Video Products Technical Bulletin 30-2017-153

SUBJECT: **MANUAL CORRECTION—NOTES ON HDR
DISPLAY IN PERIODIC REPLACEMENT PARTS;
NOTES ON UPGRADING SOFTWARE VERSIONS**

MODEL: ***BVM-E171***
BVM-E171

Correct the following manual as shown in Figure 1 and Figure 2.
BVM-E171 Service Manual, 1st Edition

Figure 1

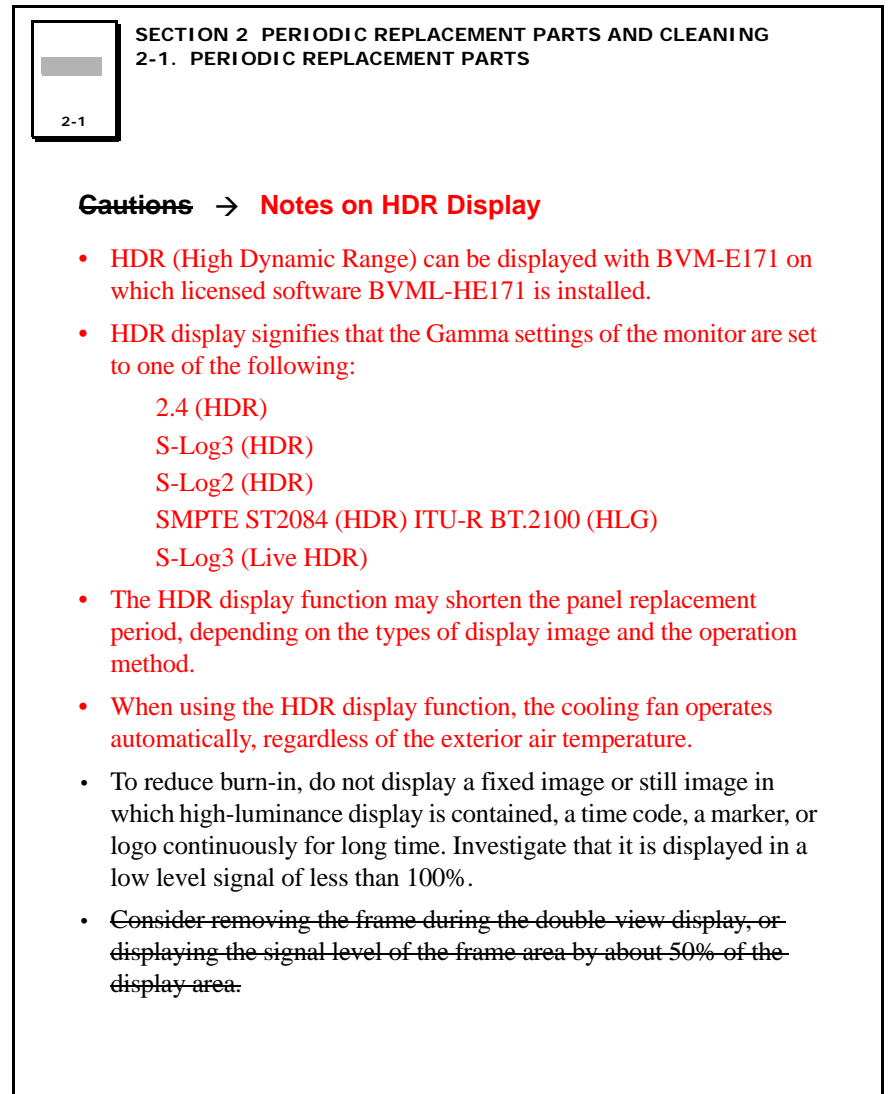
NOTE: Add the bullet points in red.
